ADDENDUM NO. 1

September 14, 2026

**Perry Meridian High School Phase 2 Renovations
401 W. Meridian School Road
Indianapolis, IN 46217**

AD102E

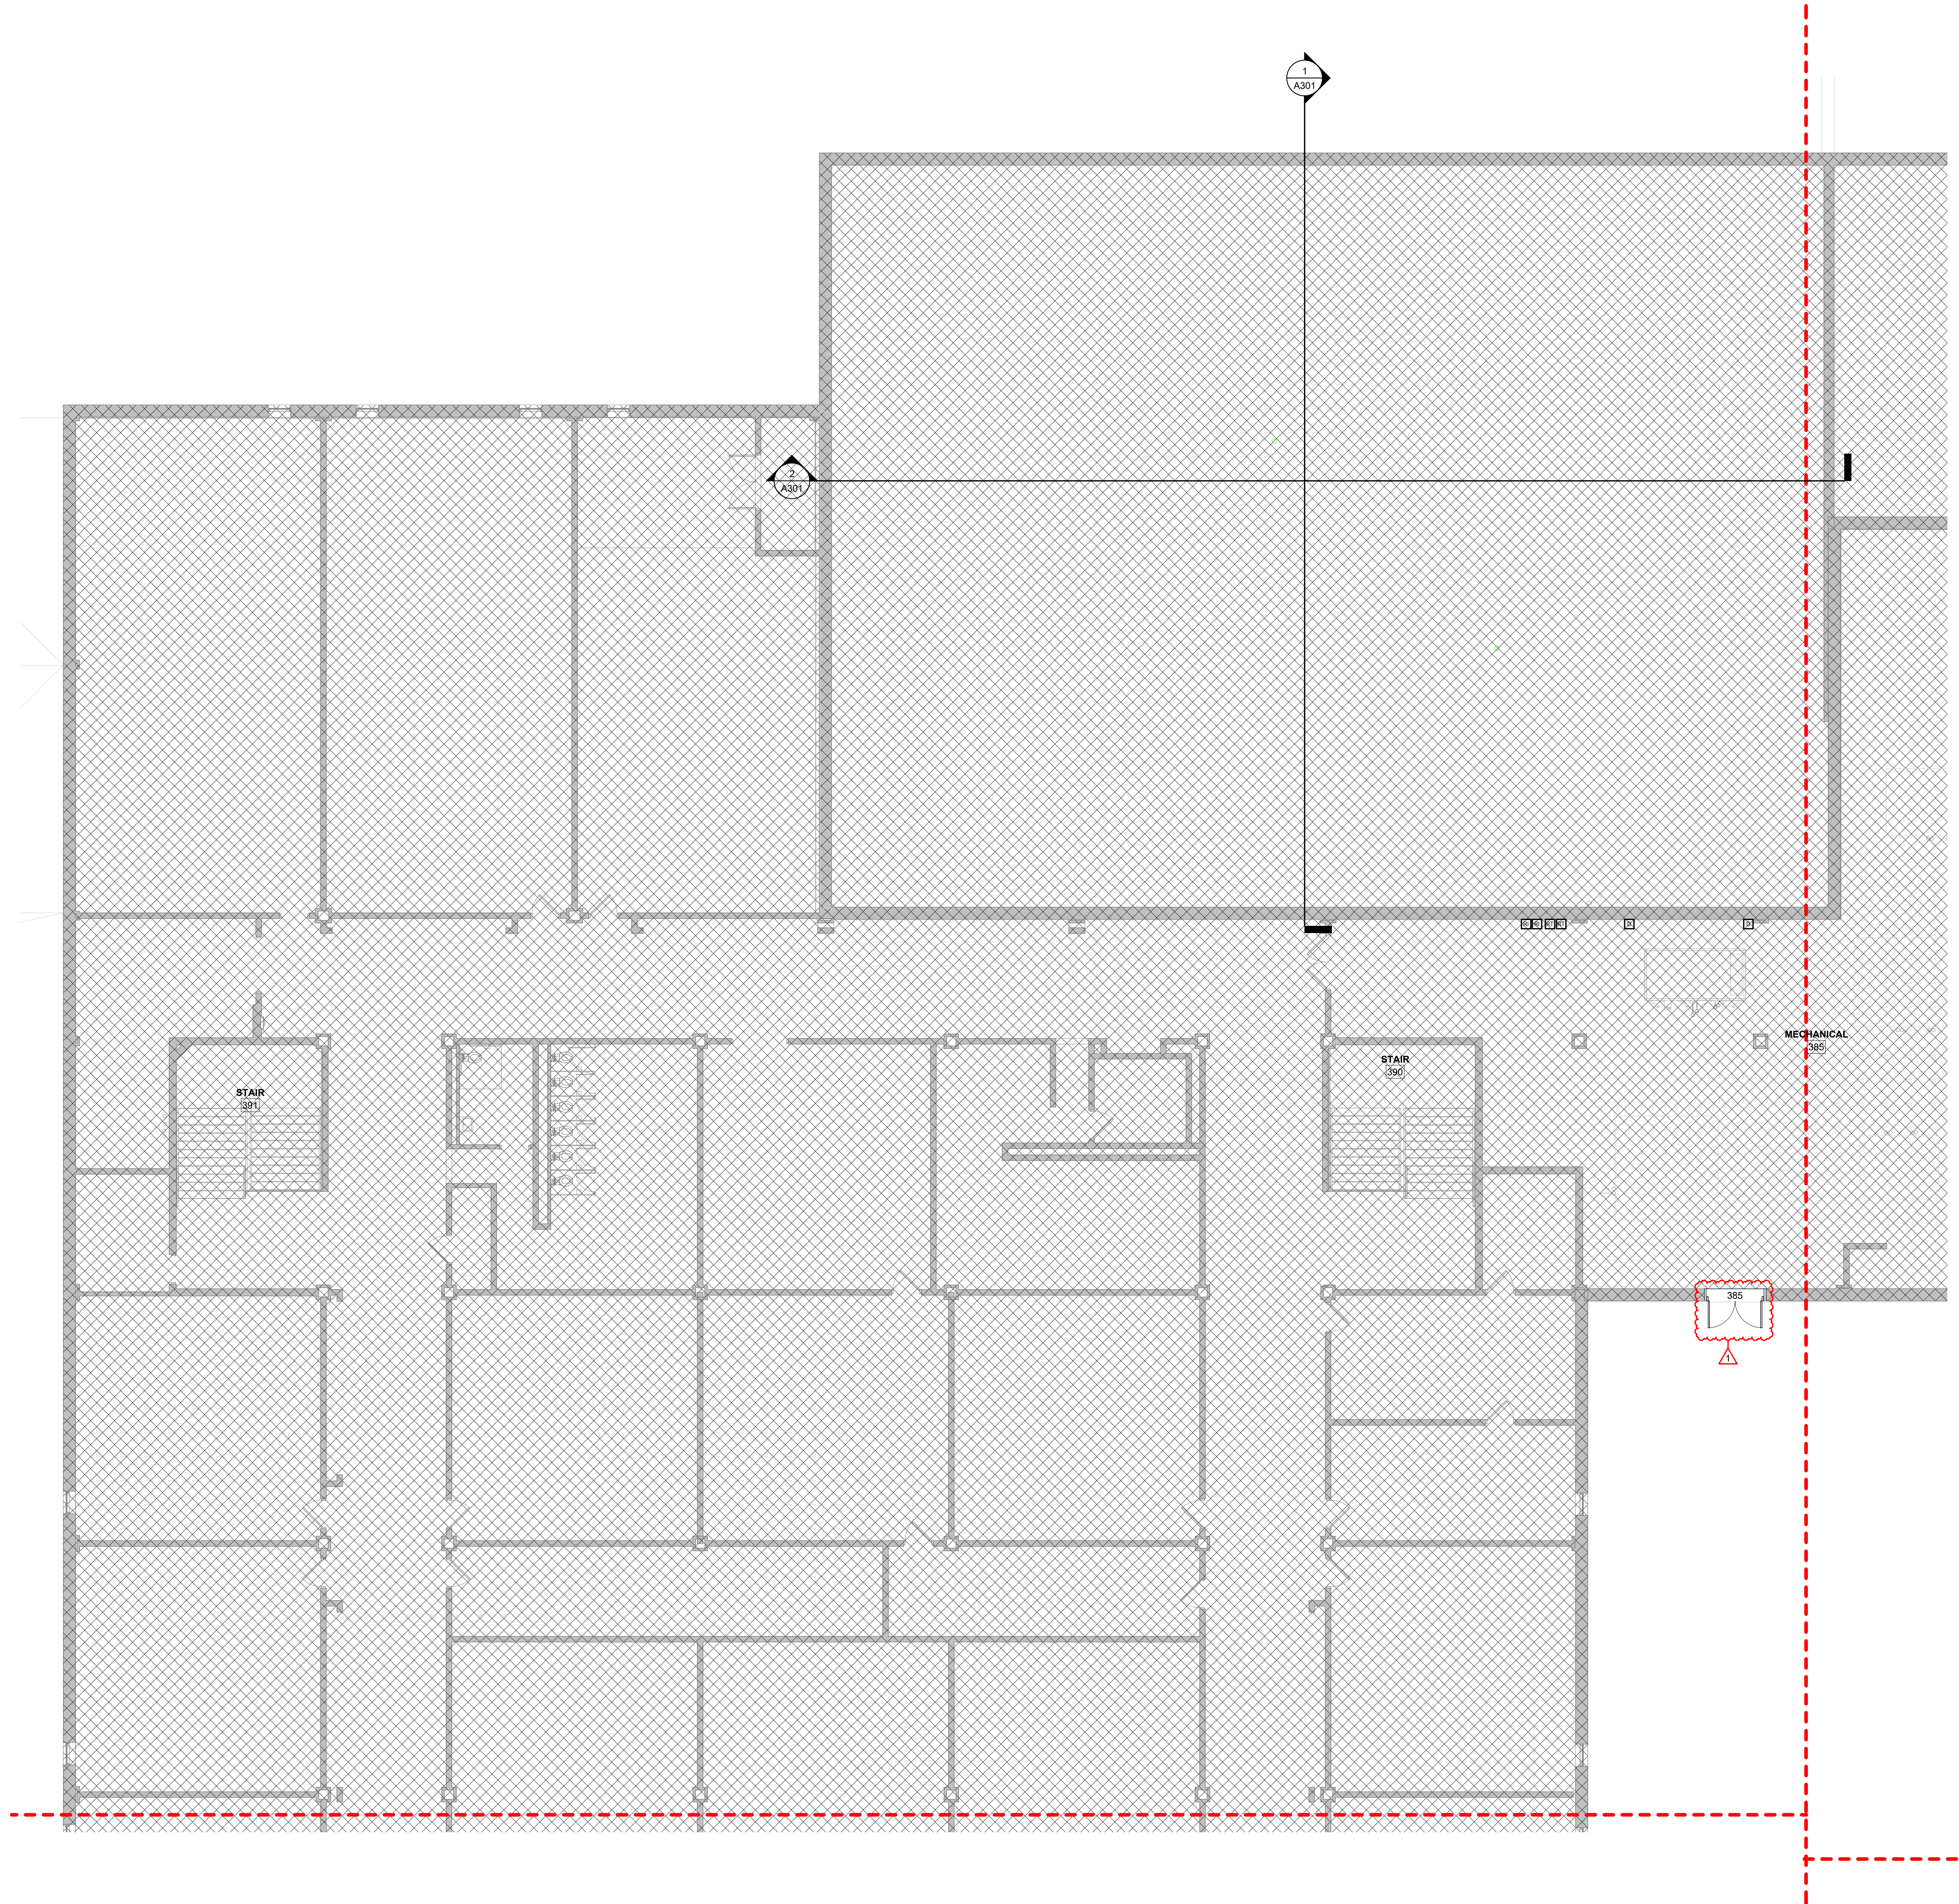
11. Drawing Sheet Number: AD102E
Drawing Sheet Title: DEMOLITION PLAN – SECOND FLOOR – UNIT D

- Sheet added to include door 382 and Business Room 2-8C in scope of work.

1 ROOF PLAN - OVERALL
SCALE: 1" = 30'-0" REF: 1 / A202

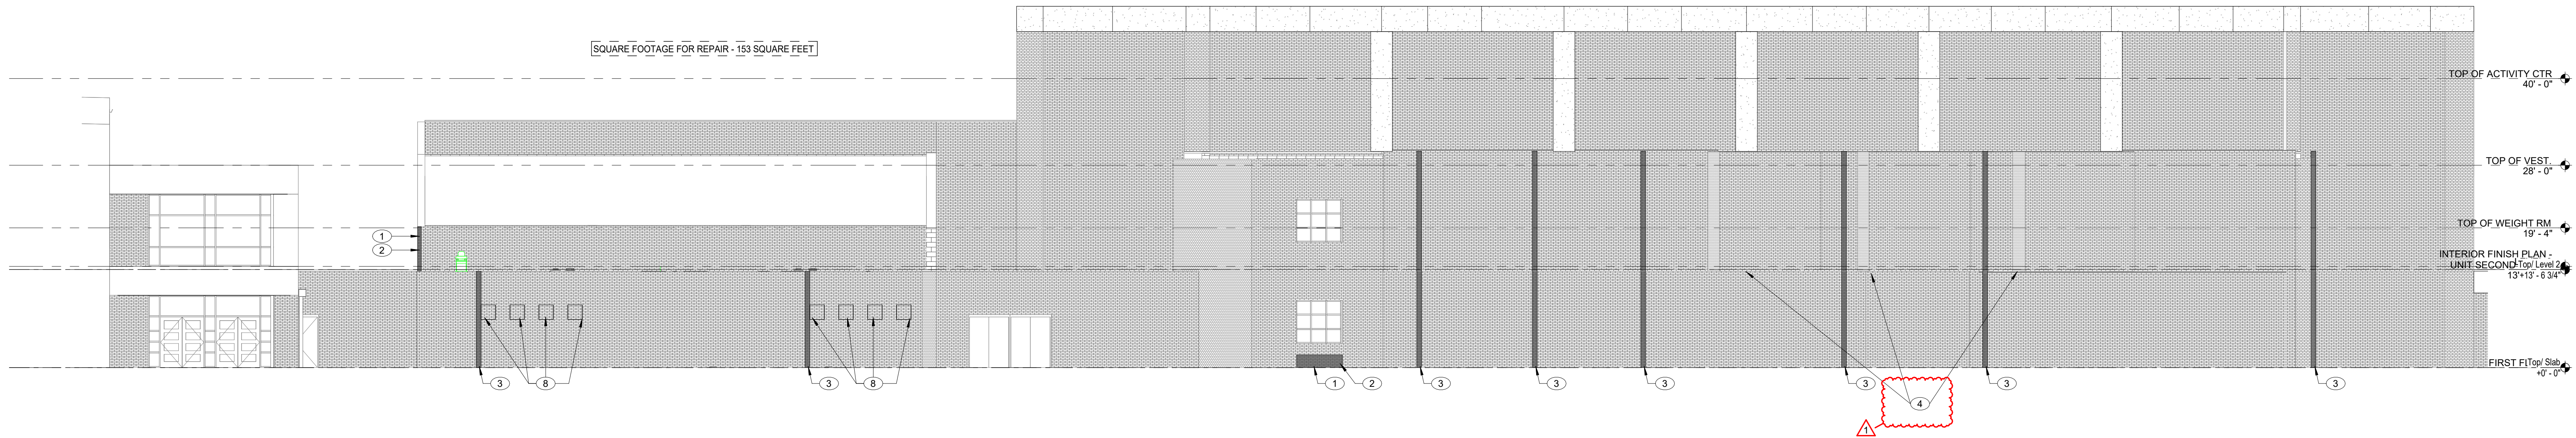
- a. See attached revised structural drawings in addendum 001.
6. **Q:** Roofing plans include elevation and section call outs for interiors. These are not relevant and should be removed.

Change: Removed interior elevation callouts

- a. Revised roof plan attached in addendum 001.
7. **Q:** Exterior Elevation Note 5 states to repair metal panels. to what extent are we expecting the contractor to 'repair' these panels? Should these state replace instead? Same question for Note 6 regarding the concrete panels. Are we going to take out sections from existing joints so these do not look like patches?

EXTERIOR ELEVATIONS

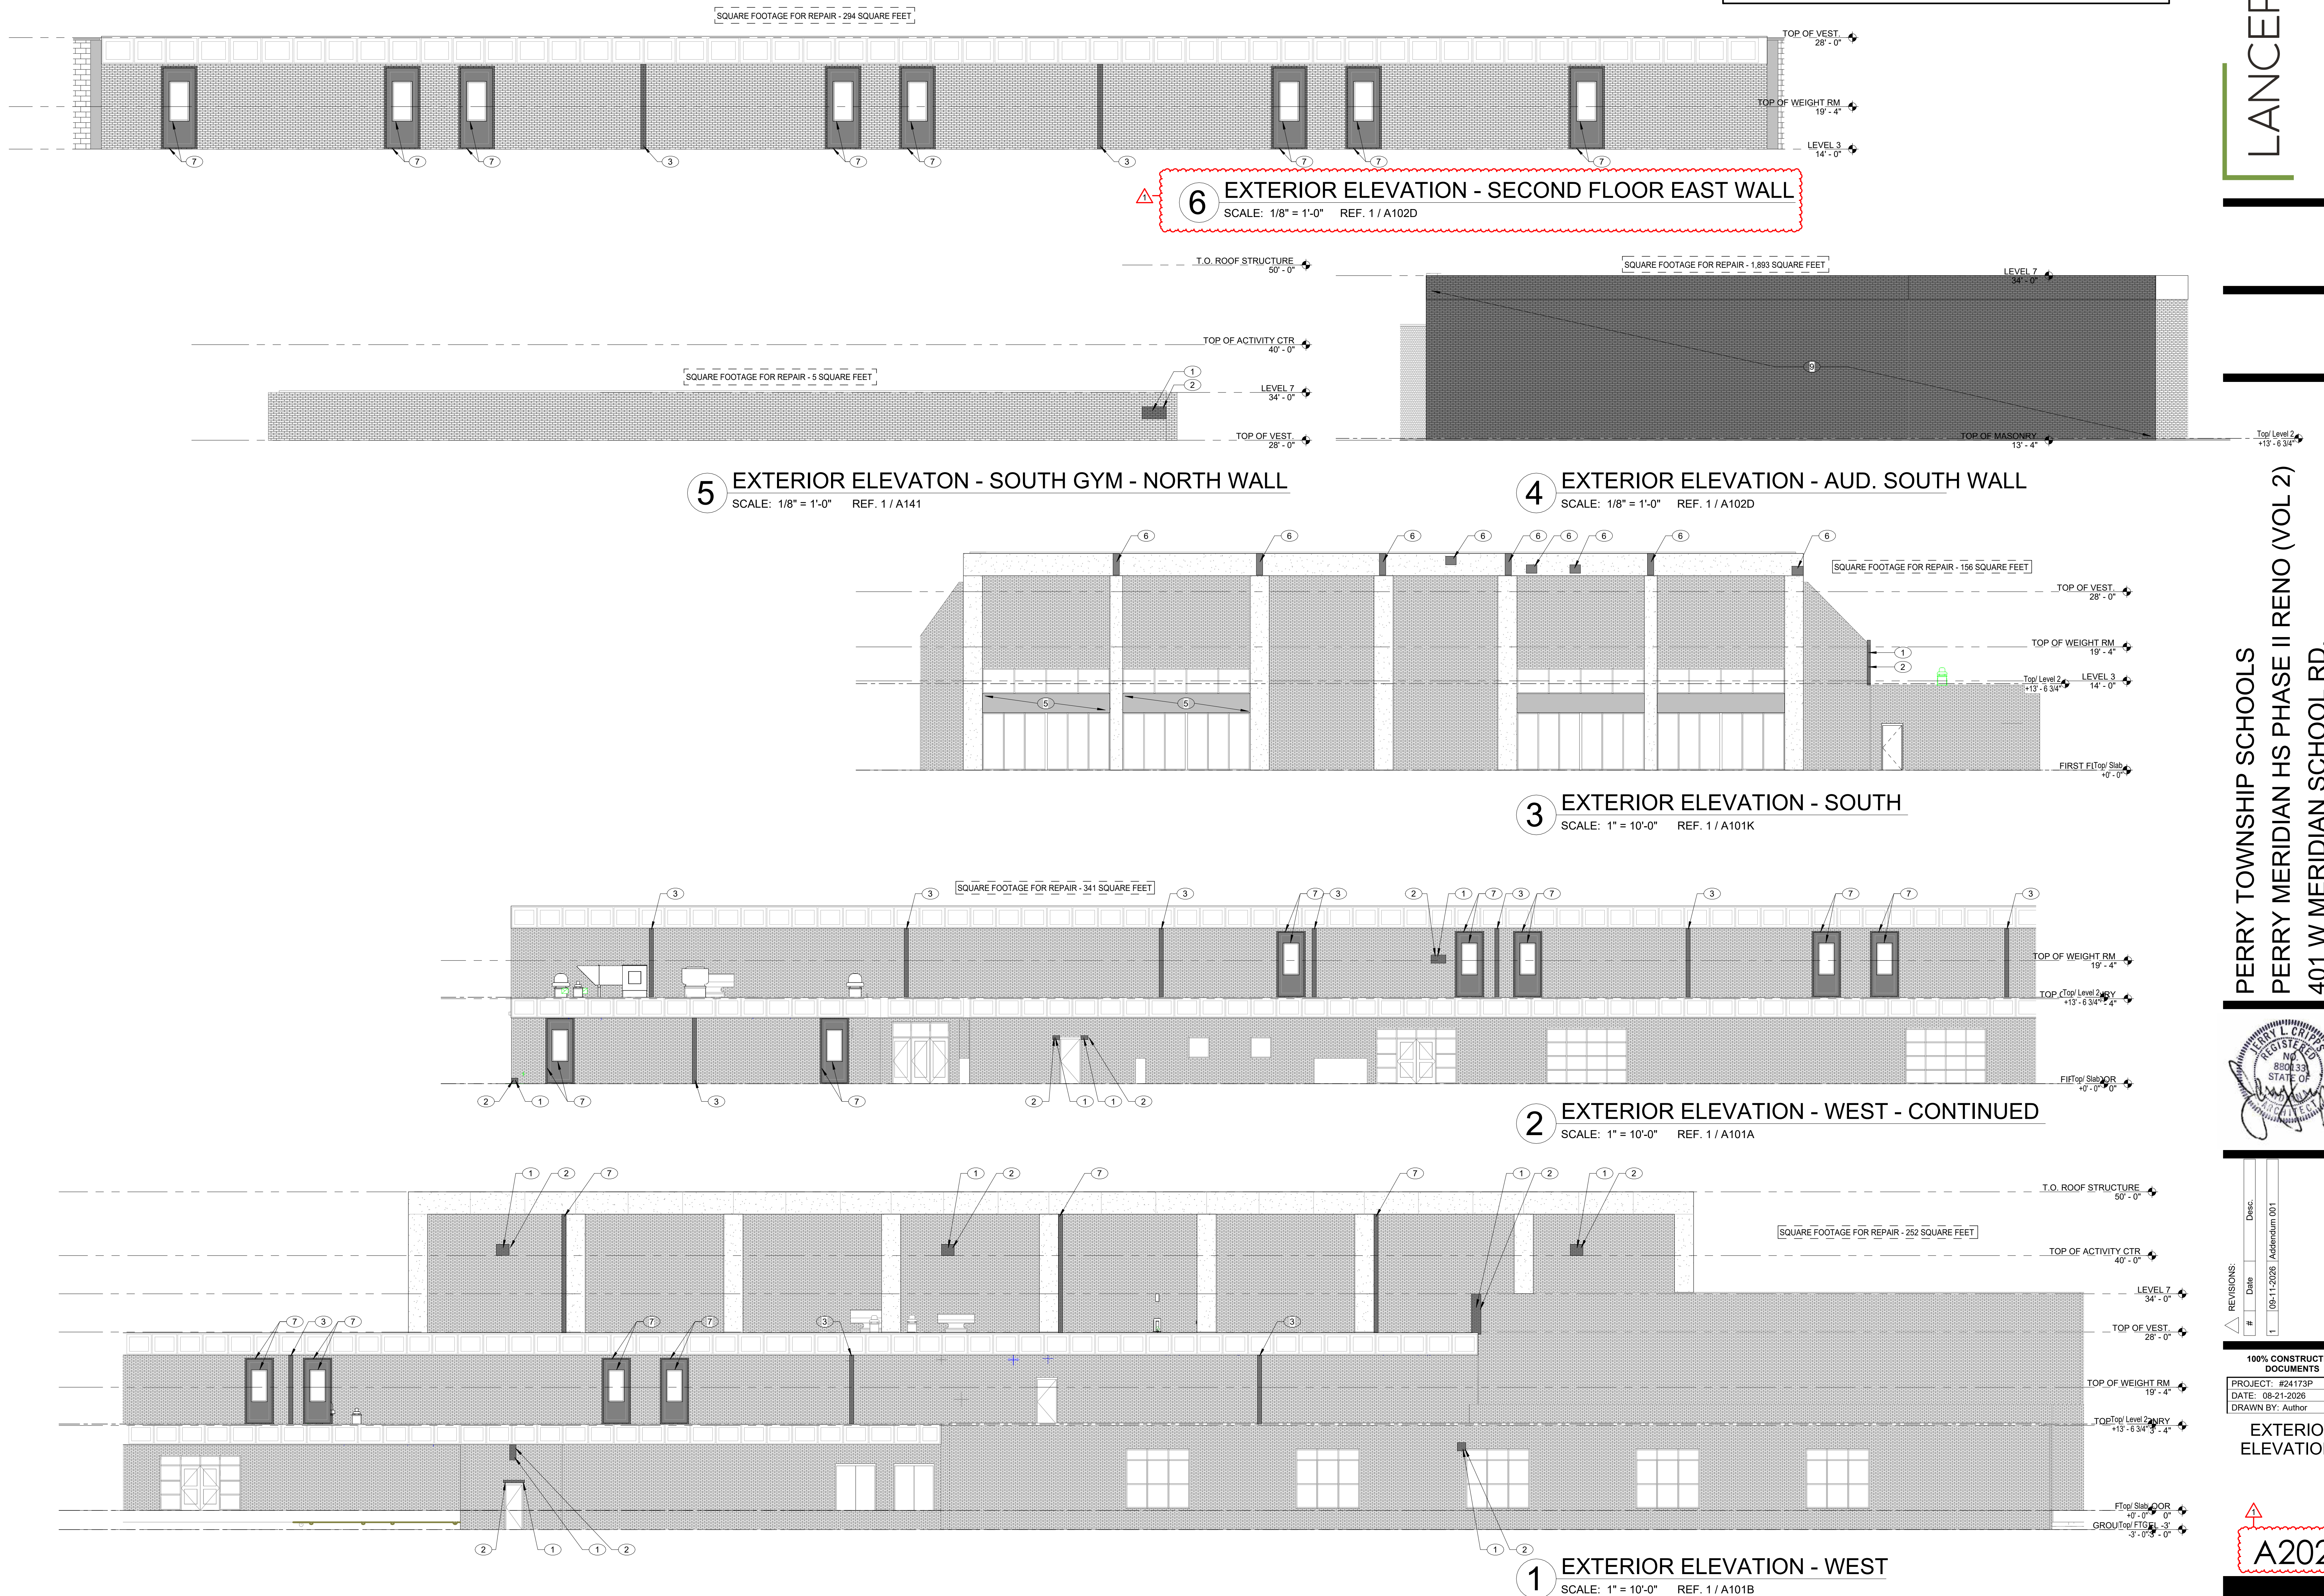
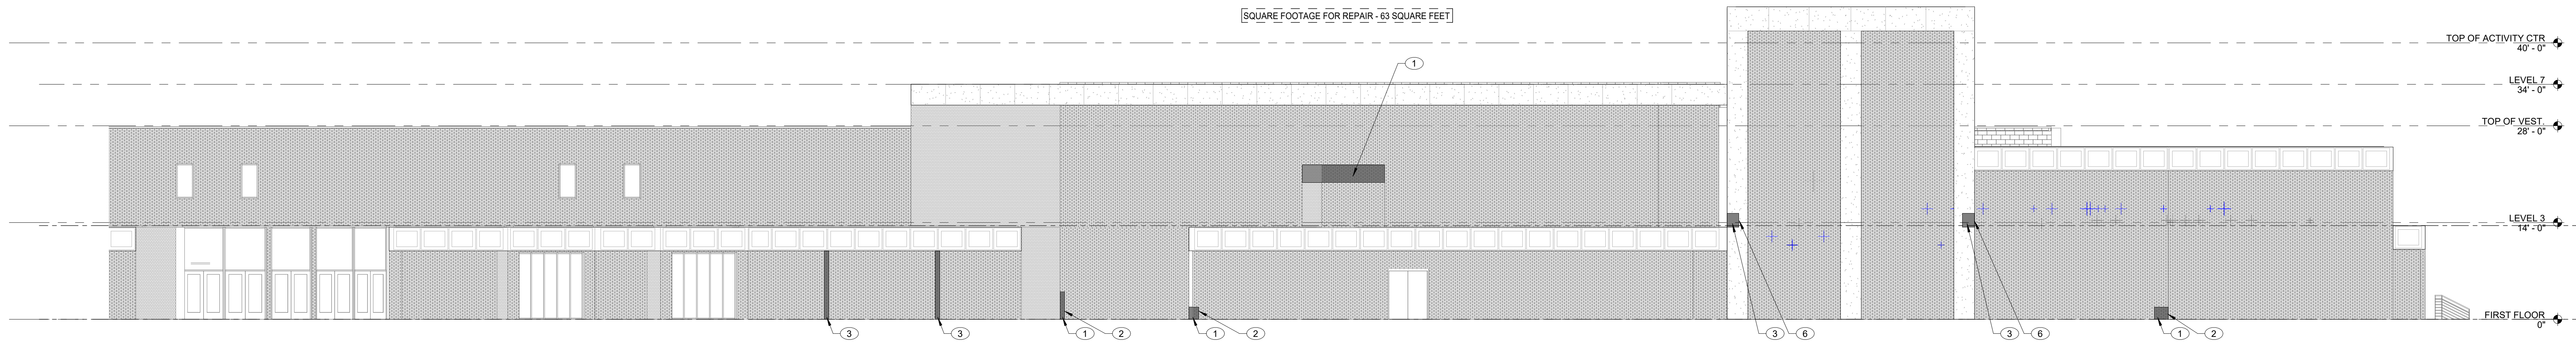
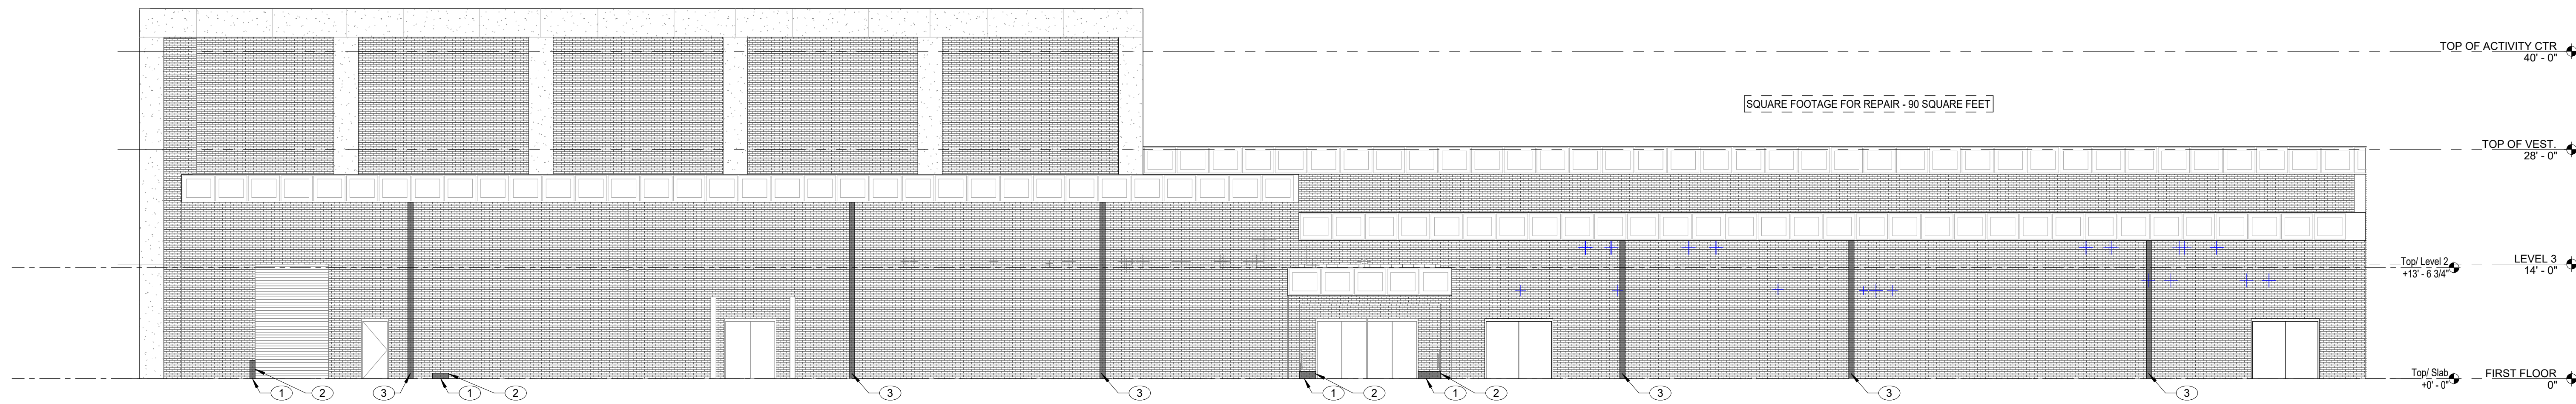
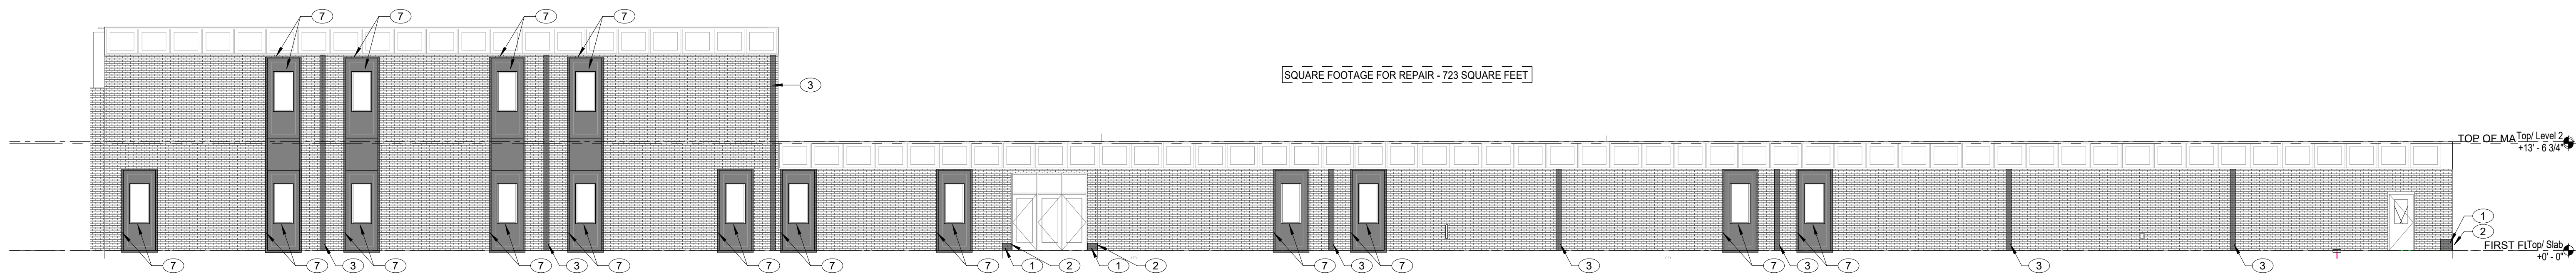
Change: Revised extent of façade repair.

- The total amount of square footage for caulking and tuckpointing was revised.
- Elevation Note 4 was added.

Change: Revised extent of façade repair.

- The total amount of square footage for caulking and tuckpointing was revised.
- Drawing number 6 was added.
